PROJECT COMMENTS

PROJECT NUMBER: SP2025-018

PROJECT NAME: Site Plan for 3070 N Goliad Street

SUBJECT: SP2025-018; Site Plan for 3066 & 3068 N. Goliad Street

ELEVATIONS

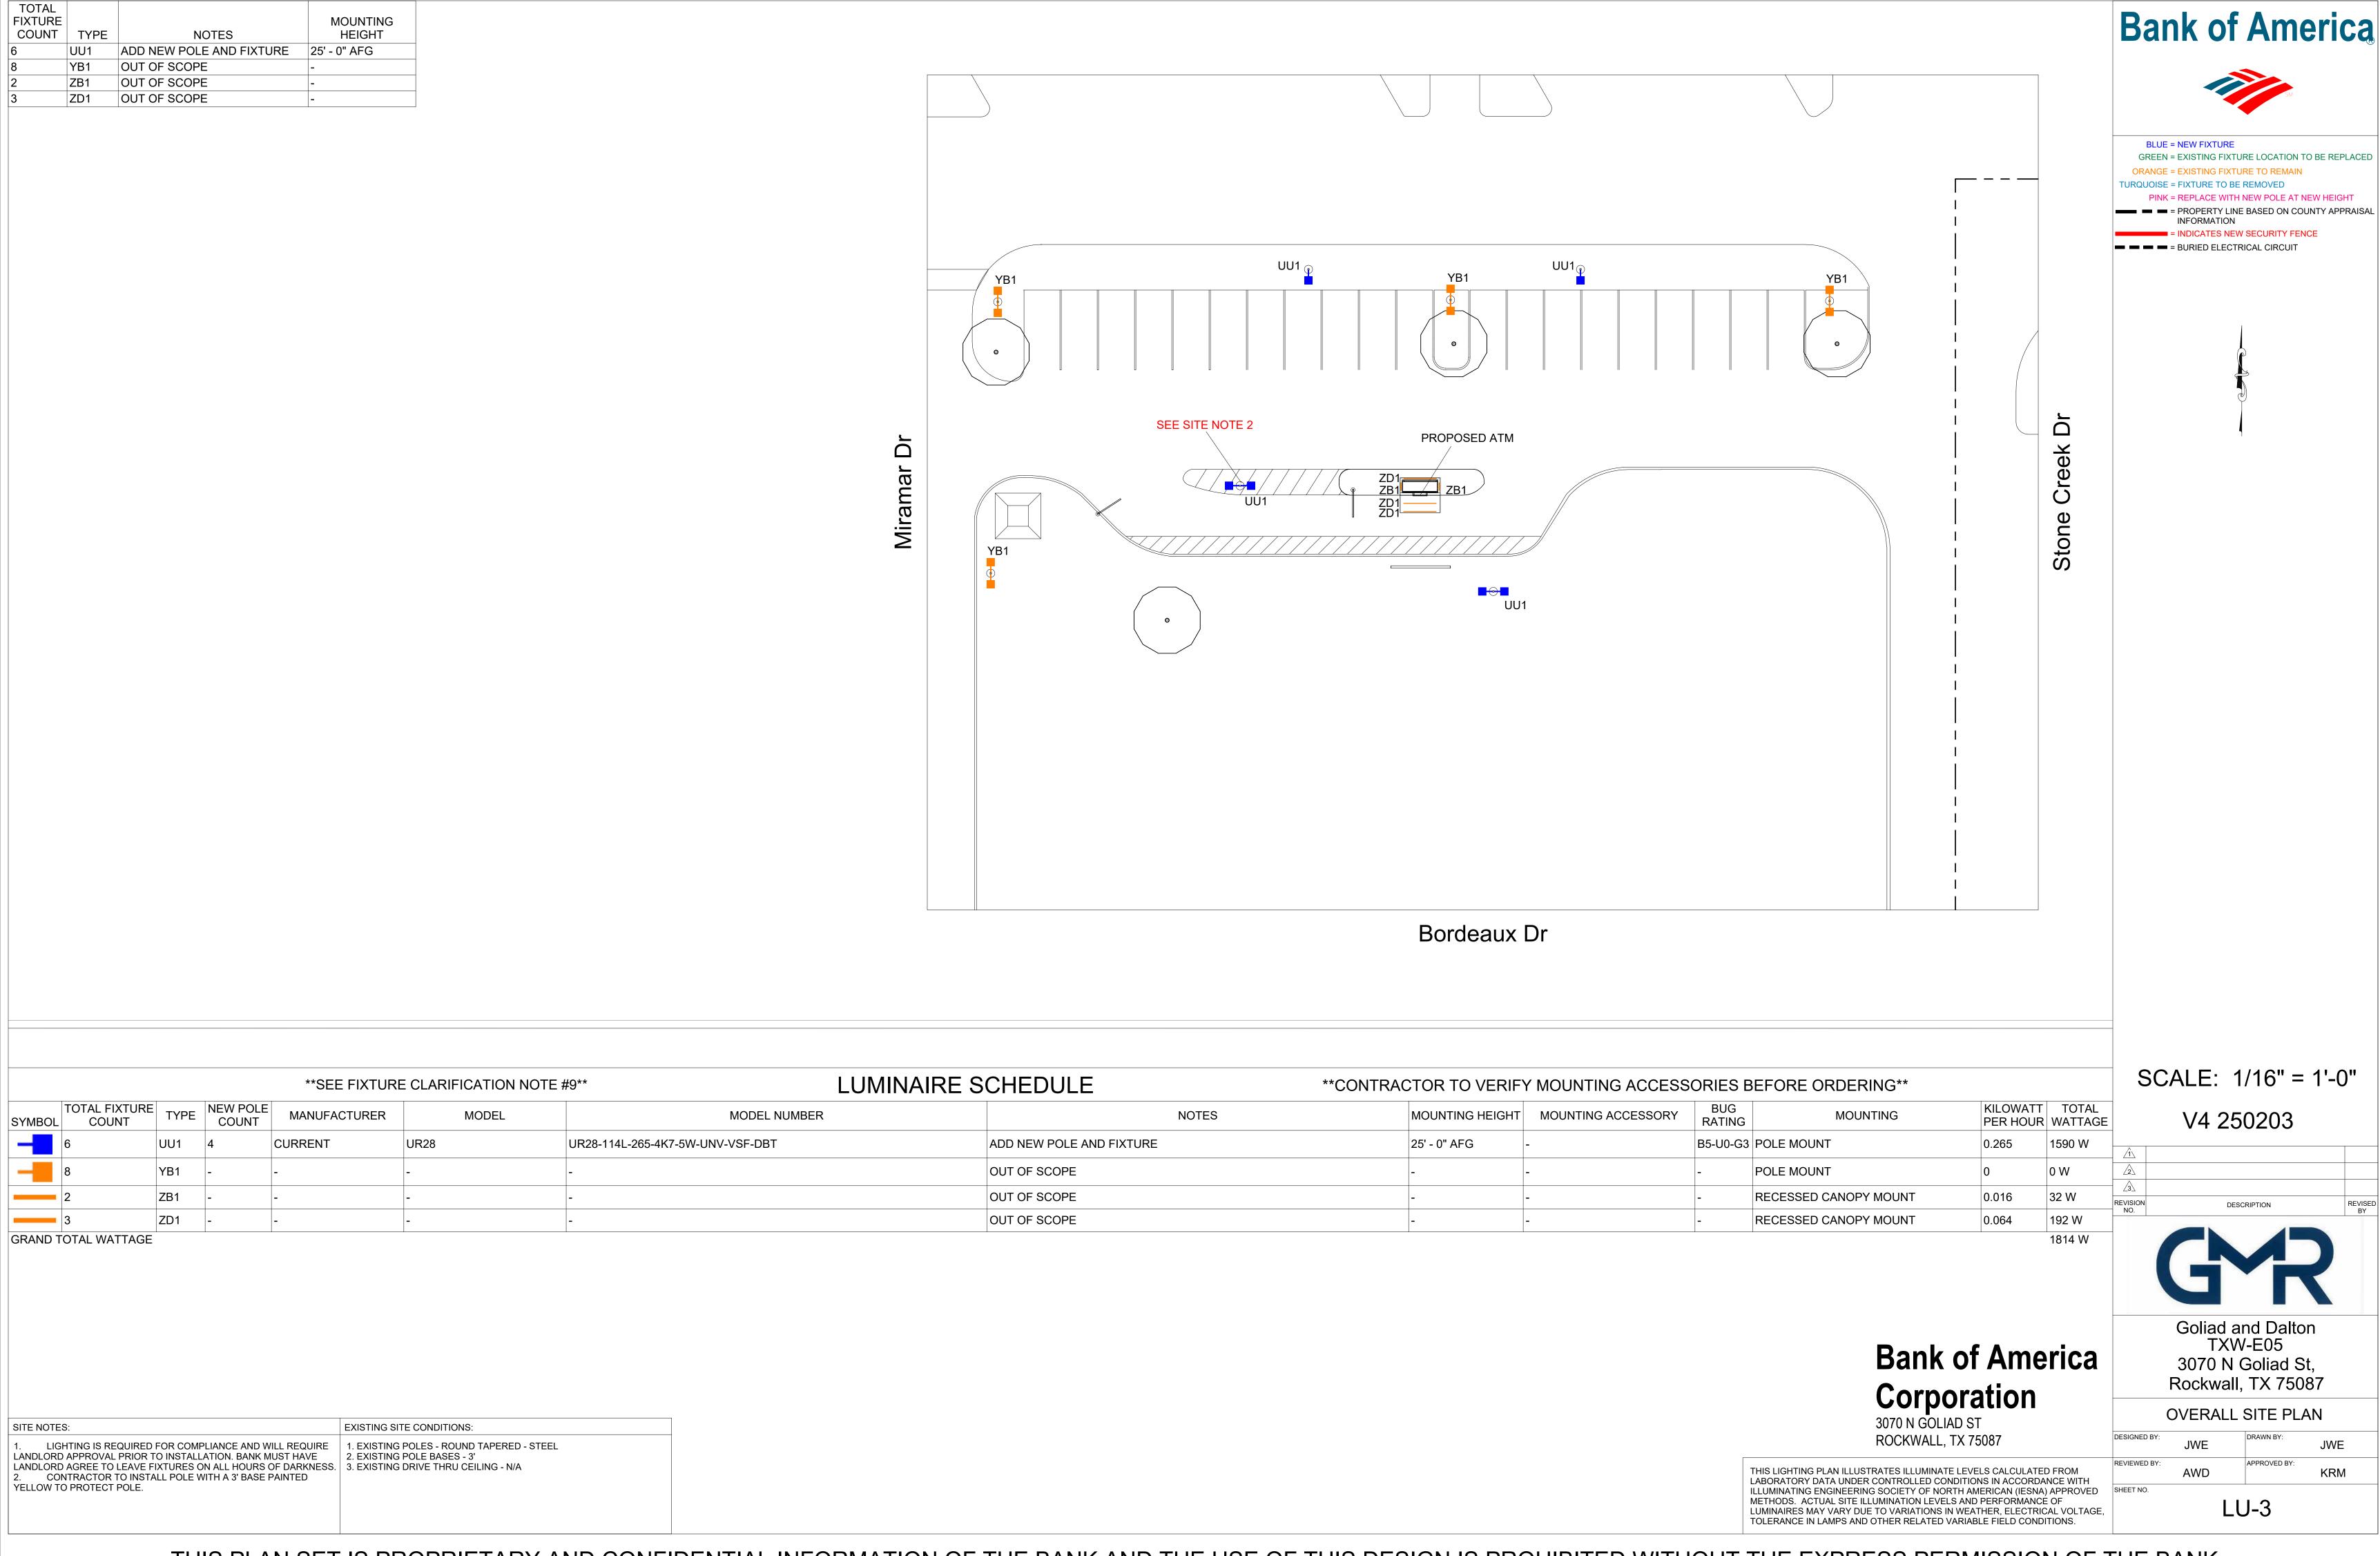
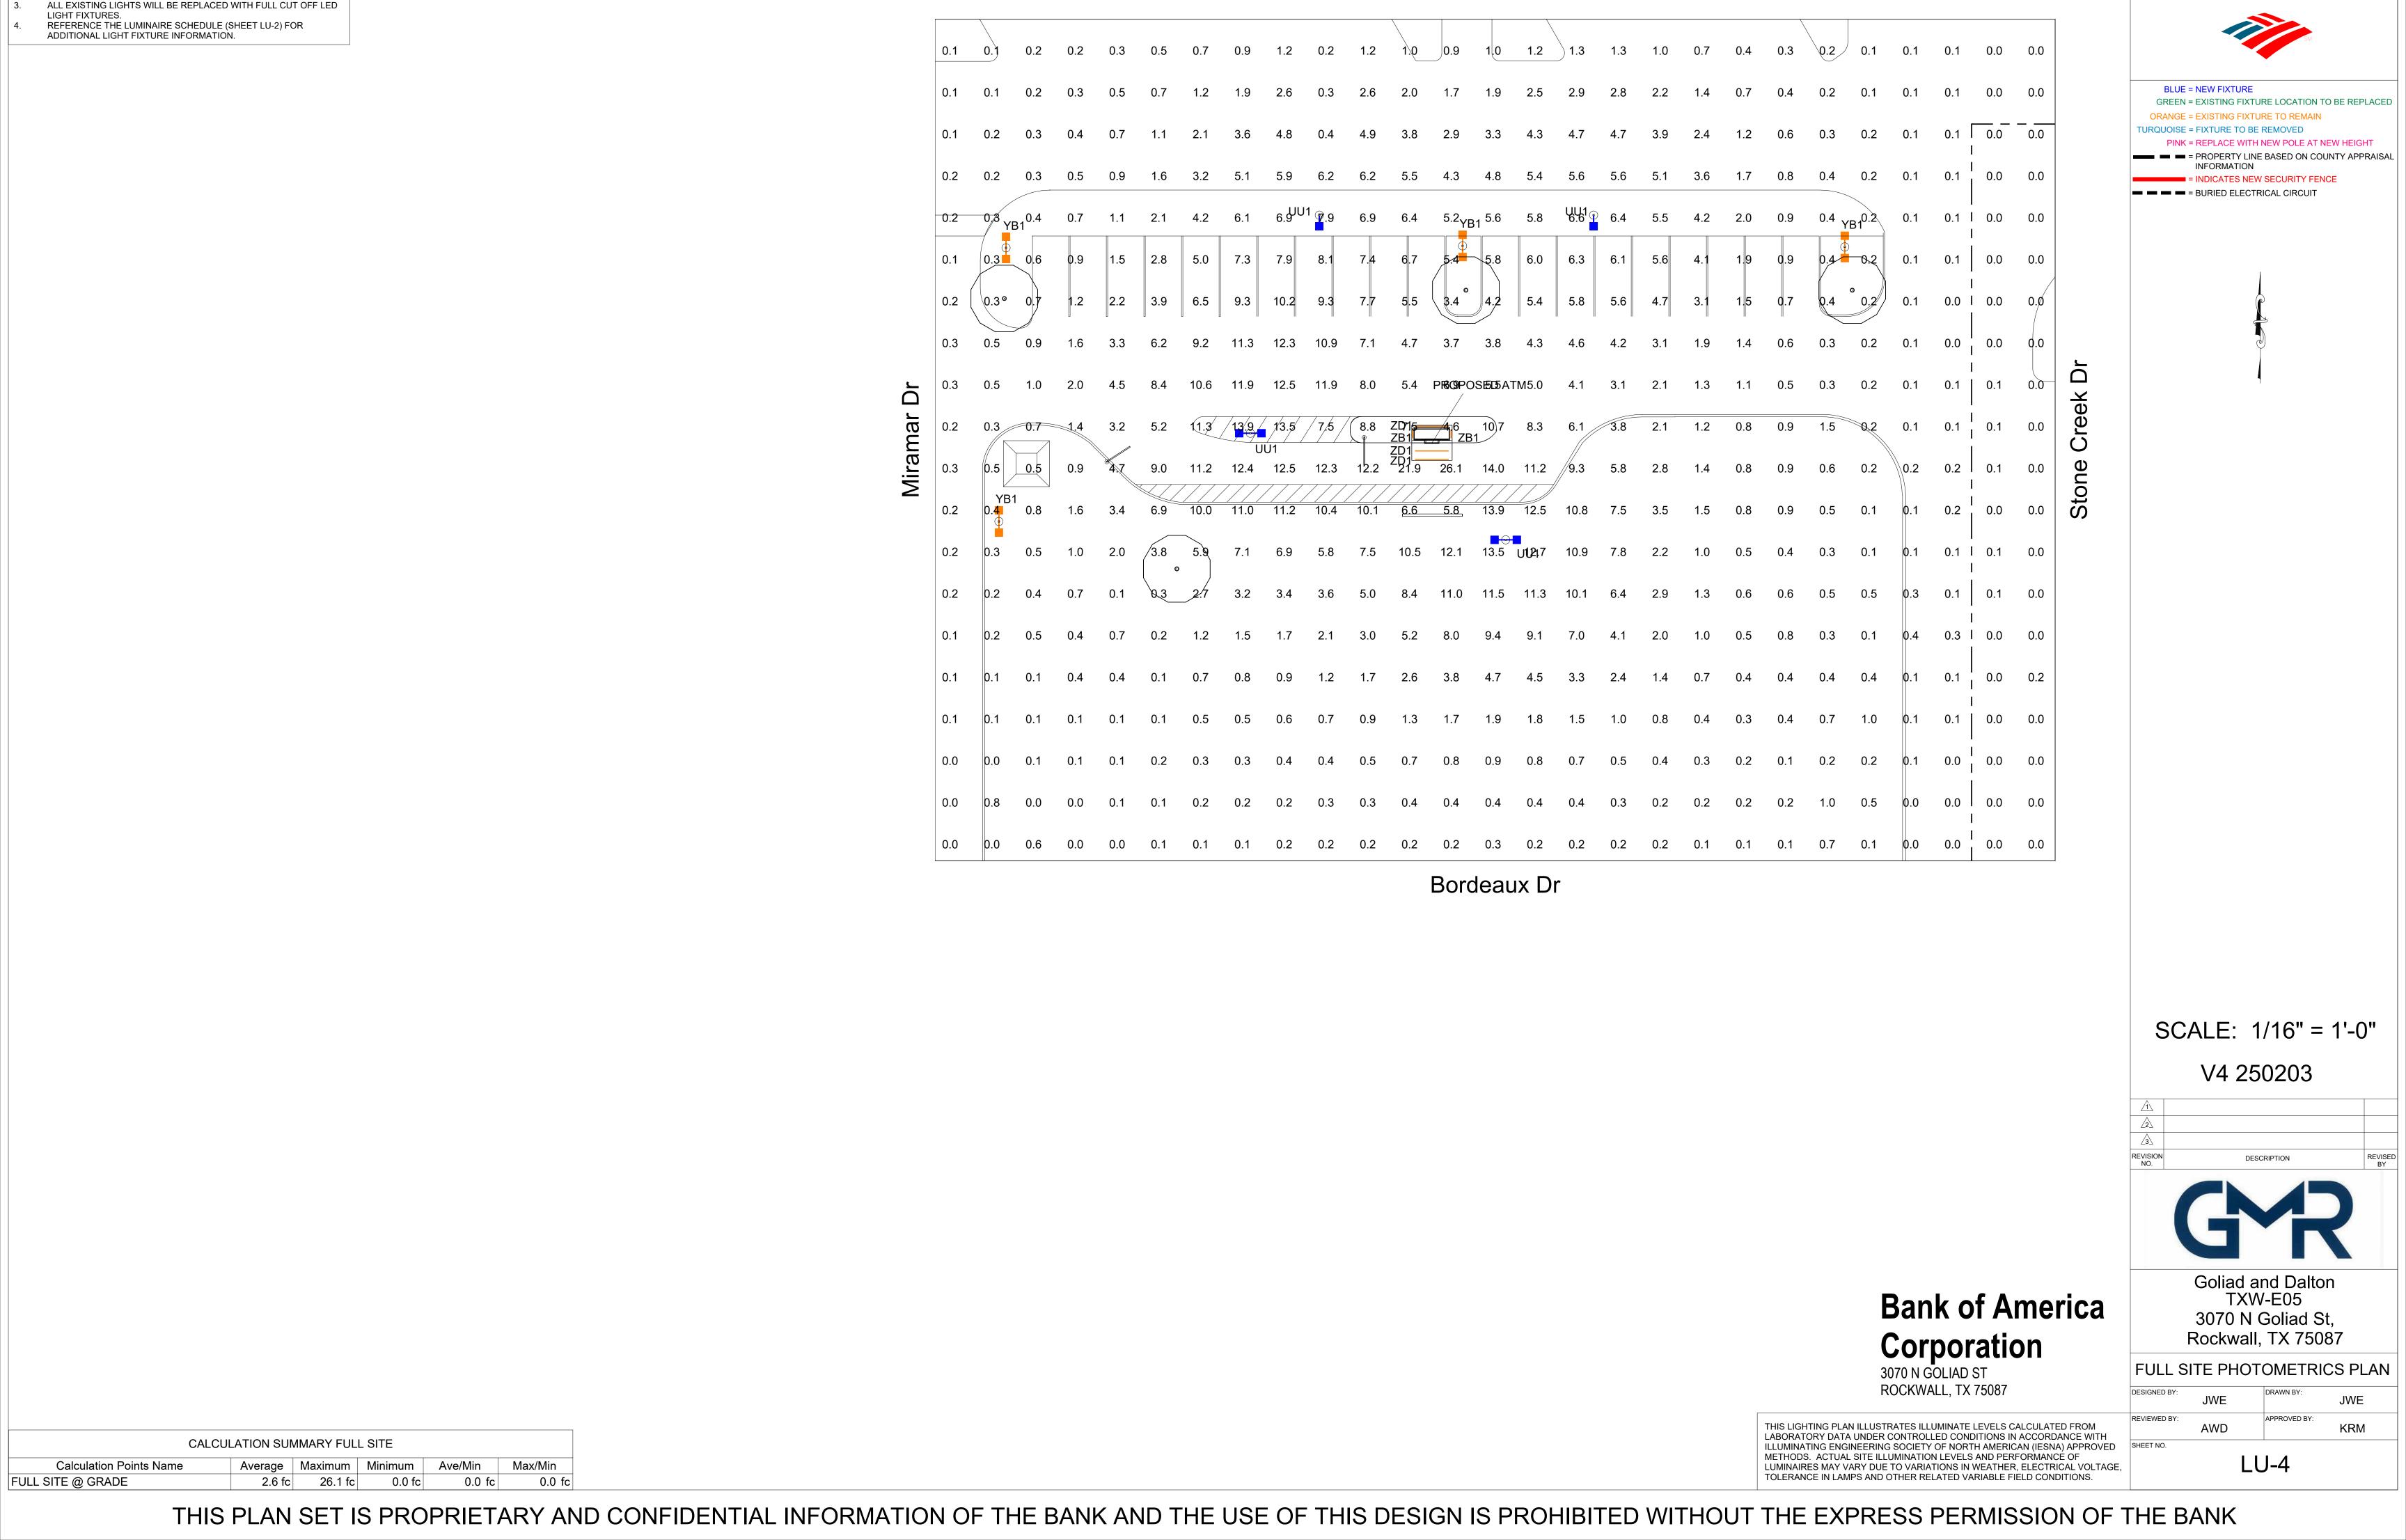
M.8 Building Elevations

- (1) The subject property is located within the North SH-205 Overlay District (N. SH-205 OV). Given this, the proposed Incidental Display and the canopy are subject to the material requirements. They must incorporate 20% natural or quarried stone, and 90% masonry materials. This will be variance to the Unified Development Code (UDC). (Subsection 06.02, of Article 05, UDC)
